ORIGINATION FORM

Proposed Revisions to a Standard Plans Index (Please provide all information – Incomplete forms will be returned)

FY 2019-20 STANDARD PLANS CONCRETE BARRIER/RAISED SIDEWALK
- WALL COPING

INDEX SHEET 521-620 1 of 4

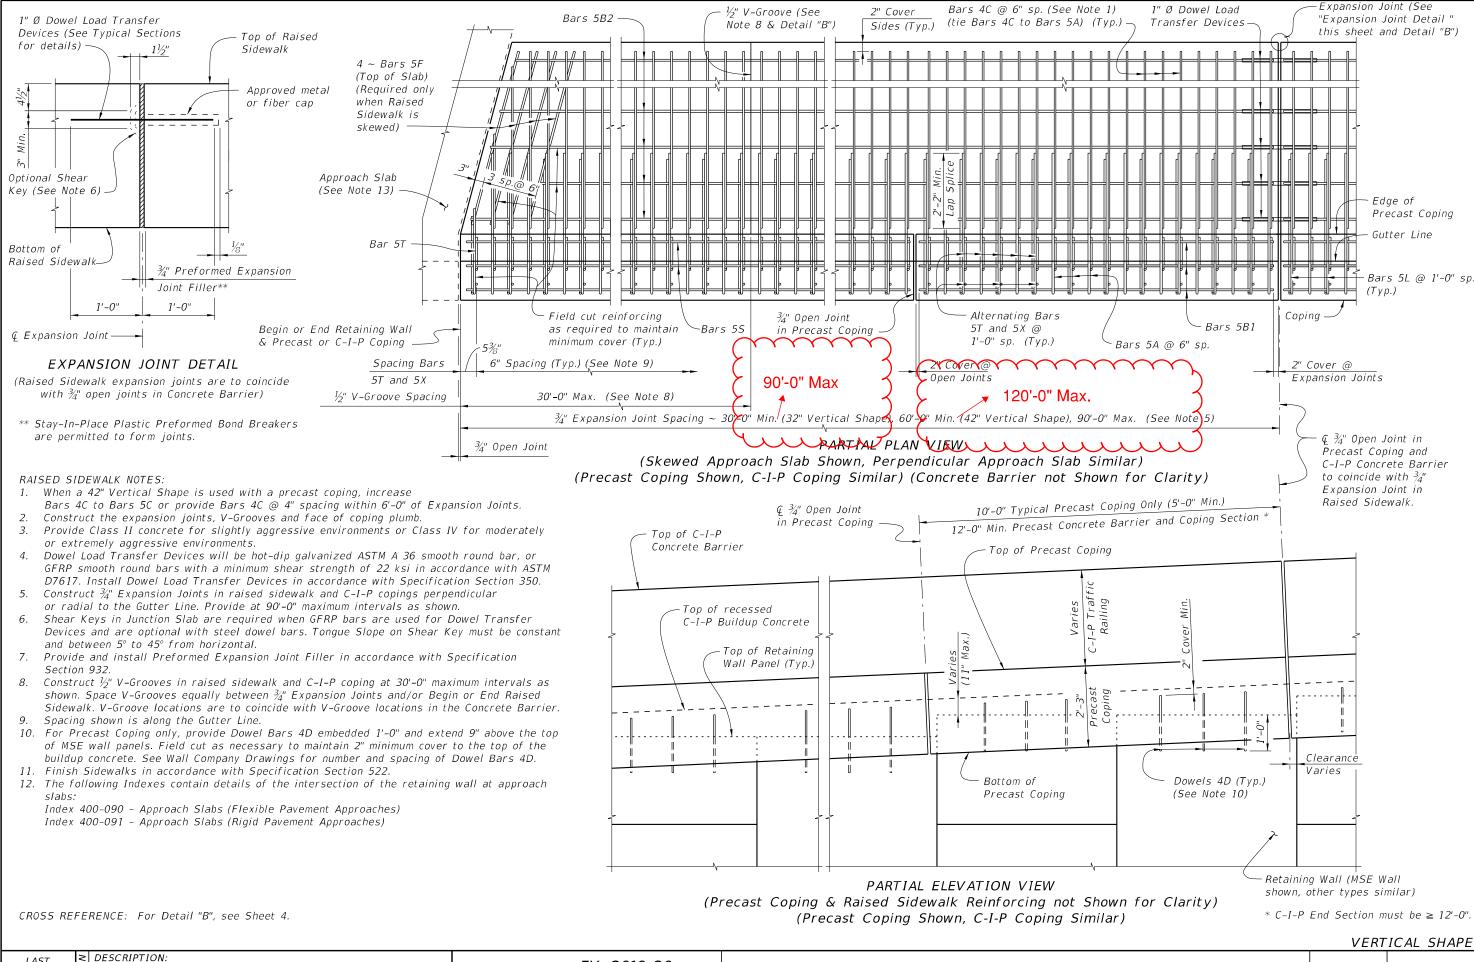
Contact Information:		Standard Plans:	
Date: January 17, 2019 Originator: Cheryl Hudson Phone: (850) 414-5332 Email: cheryl.hudson@dot.state.fl.us		Index Number: 521-620 Sheet Number (s): 1 Index Title: Concrete Barrier/Raised Sidewalk - Wall Coping	
Summary of the changes:			
Correcte	d reference to Approach Slab Note in Partial F	Plan view; Changed maximum spacing of 3/4" expansion joints	
Commen	tary / Background:		
Maximur	m spacing of expansion joints was increased to	o match minimum precast section length.	
	Other Affected Offices / Documents: (Provide name of responsible personnel)	
Yes No	Other Standard Plans –		
	FDOT Design Manual –		
	Basis of Estimates Manual –		
	Standard Specifications – Andre Pavlov		
	Approved Product List –		
	Construction –		
	Maintenance –		
	Origination Package Includes: (Email or h	nand deliver package to Derwood Sheppard)	
Yes N/A ☐ ✓	Redline Mark-ups		
	Proposed Standard Plan Instructions (SPI)
